**Fox Falls Off-Site Gravity Sewer  
Solicitation Number: CO-00673  
Job No.: 22-1592**

**ADDENDUM 2  
July 17, 2023**

C15

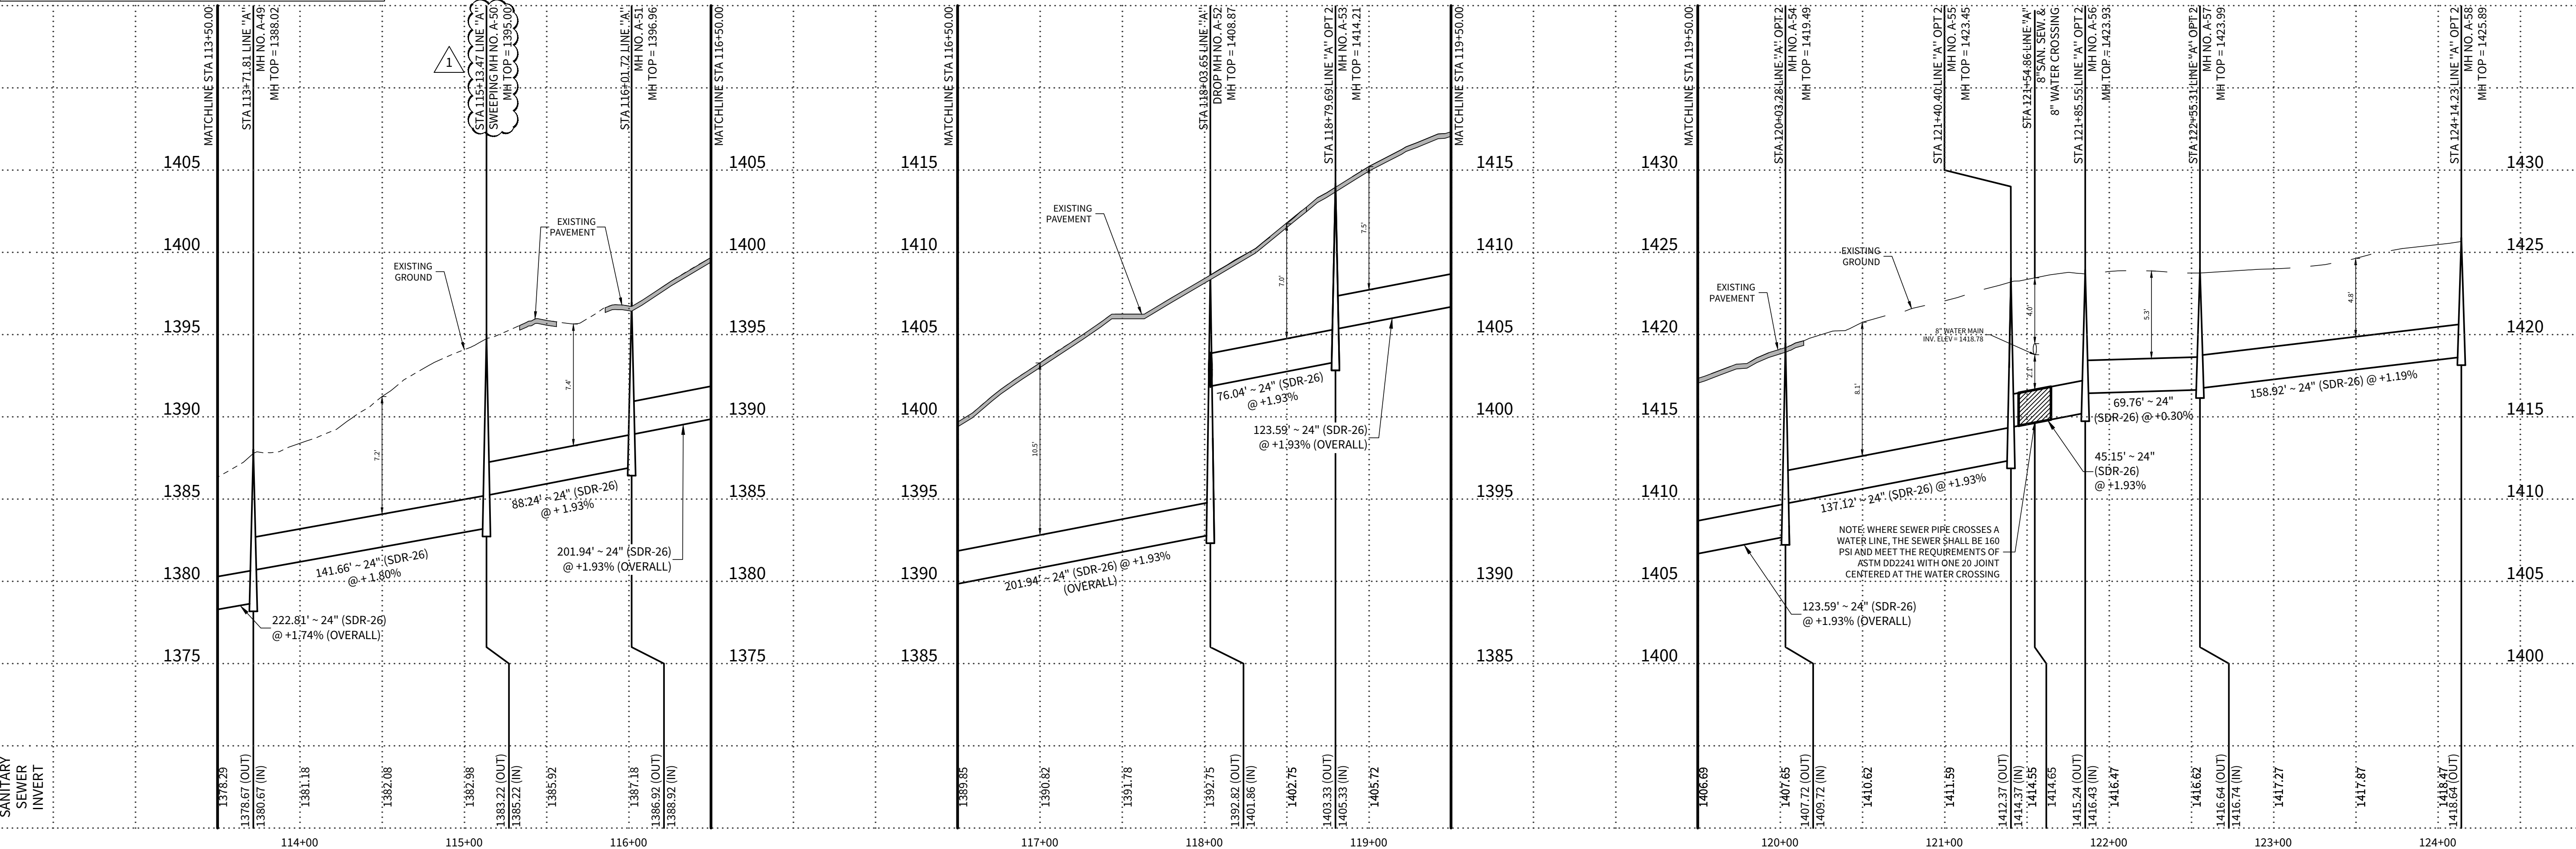
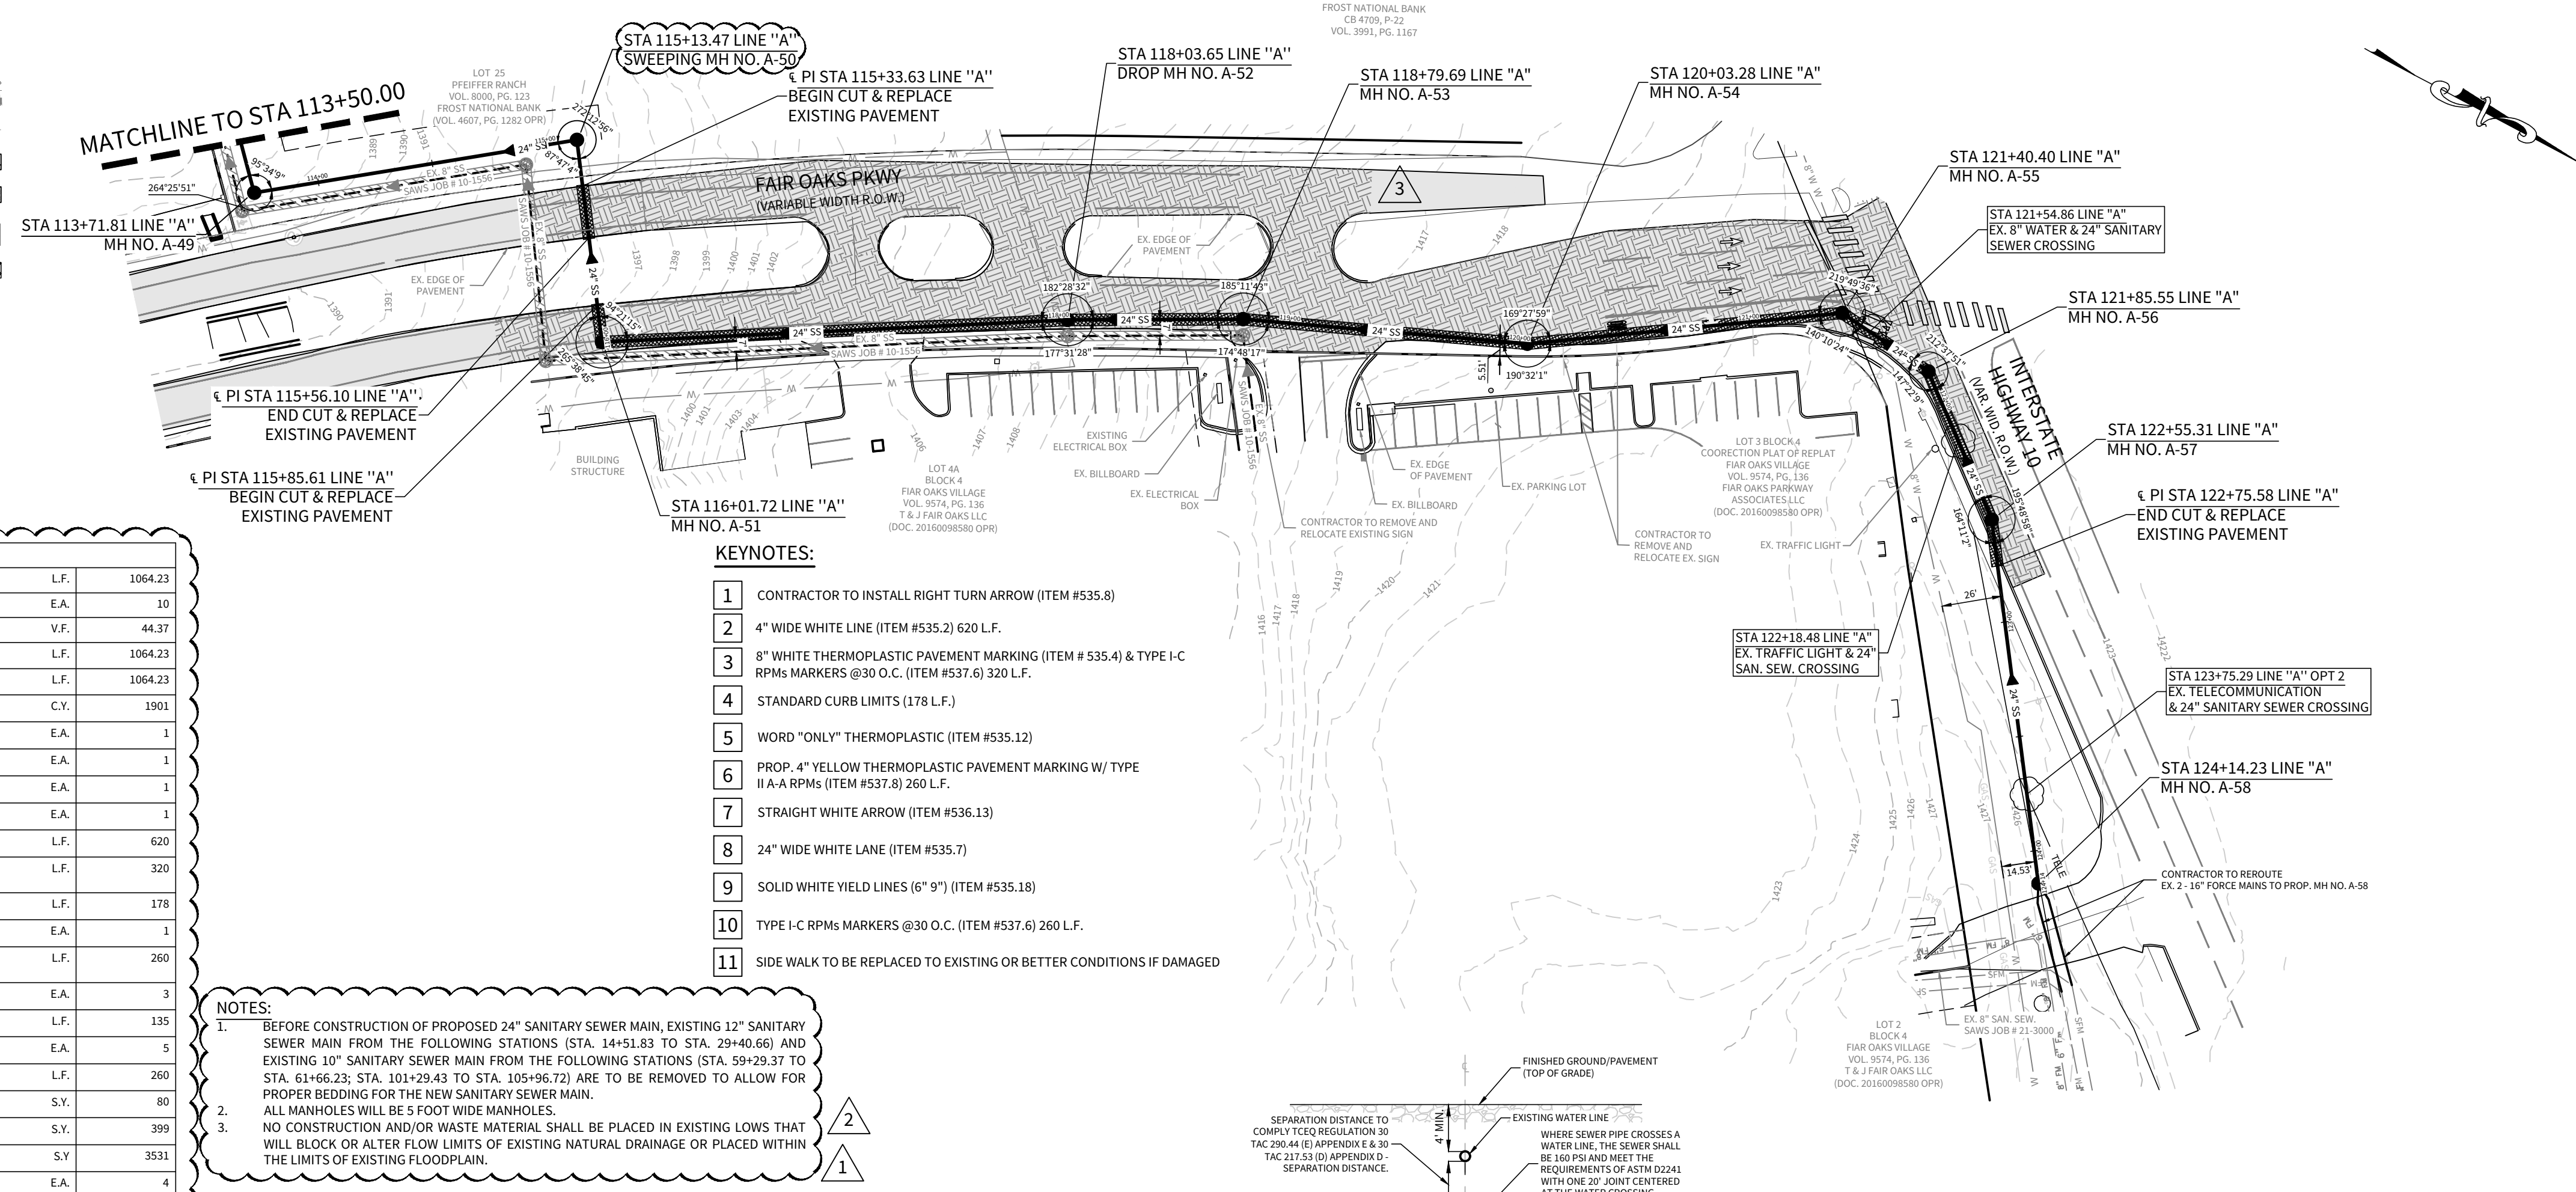
1. Remove and replace sheets C15 and C22 with the version provided with this addendum.
